FEDERAL TRADE COMMISSION

Energy Labeling Rule

ACTION: Final rule; correction.

SUMMARY: The Federal Trade Commission (“Commission”) is correcting a final rule published in the Federal Register of August 12, 2014, which amends the Energy Labeling Rule by updating comparability ranges for certain heating and cooling products and making conforming changes to the Rule’s sample labels.

Appendix I to Part 305 [Corrected]

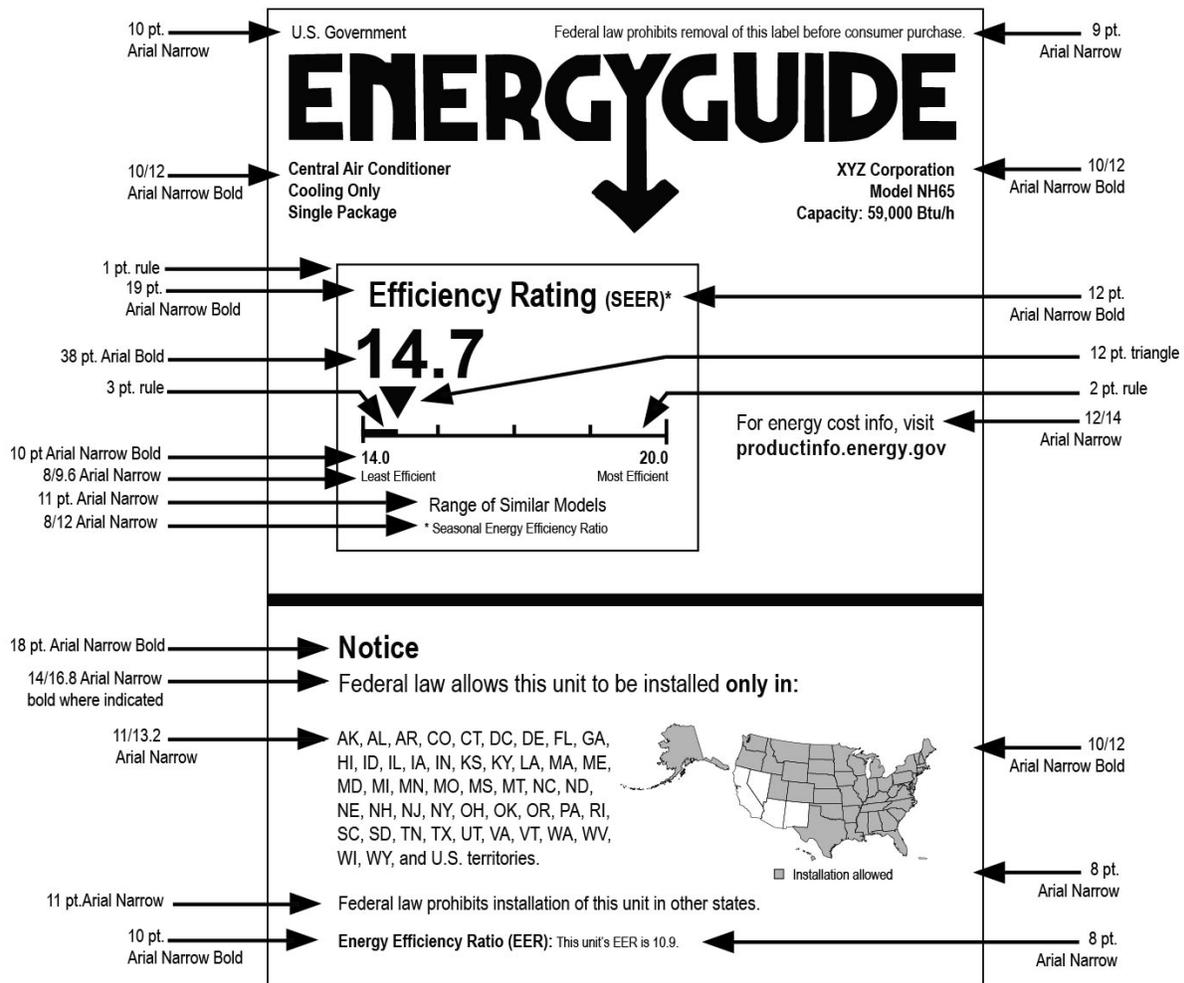
- 2. On pages 46986 through 46987, the table in Appendix I to Part 305 is corrected to read as follows:

Prototype Label 3 – Single-Package Central Air Conditioner (models manufactured after the compliance date of DOE regional efficiency standards in 10 CFR part 430)

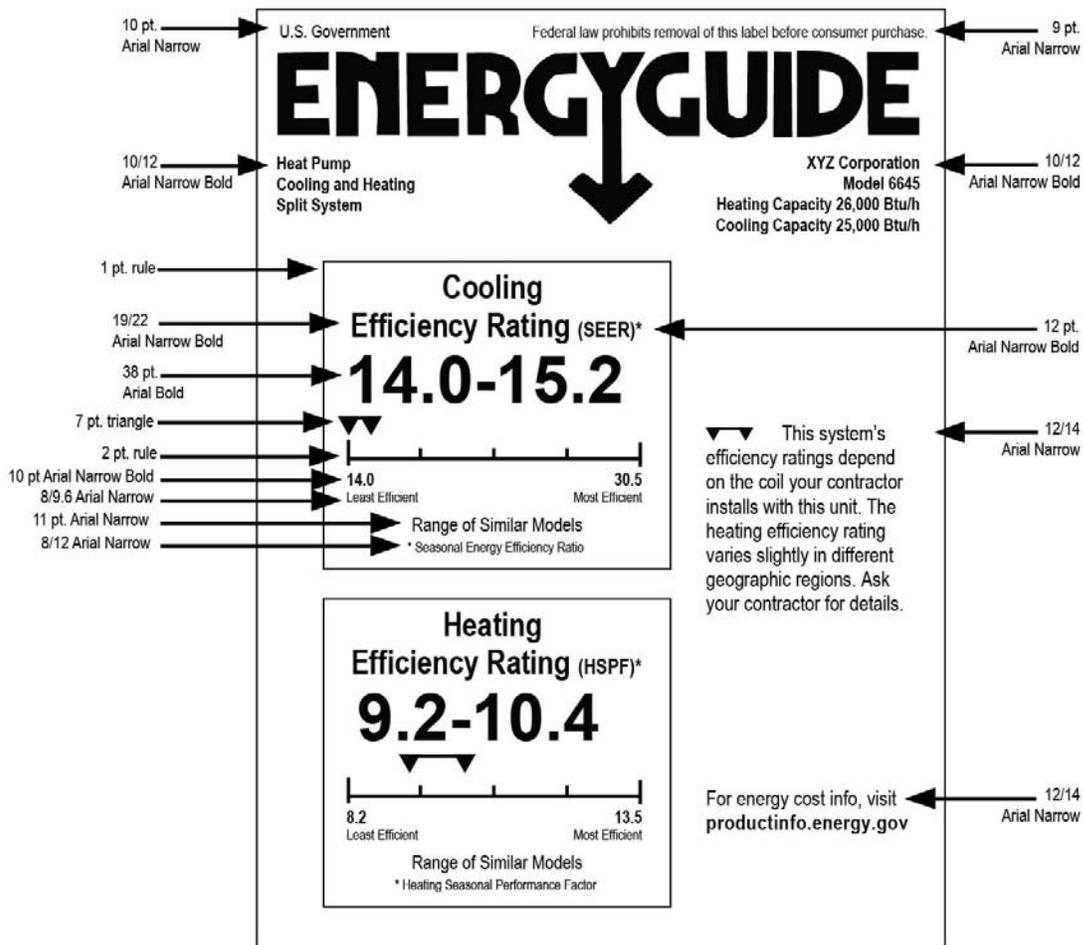
- 3. On pages 46988 through 46992, Prototype Labels 3 and 4 and Sample Labels 7, 7A, and 8 are corrected to read as follows:
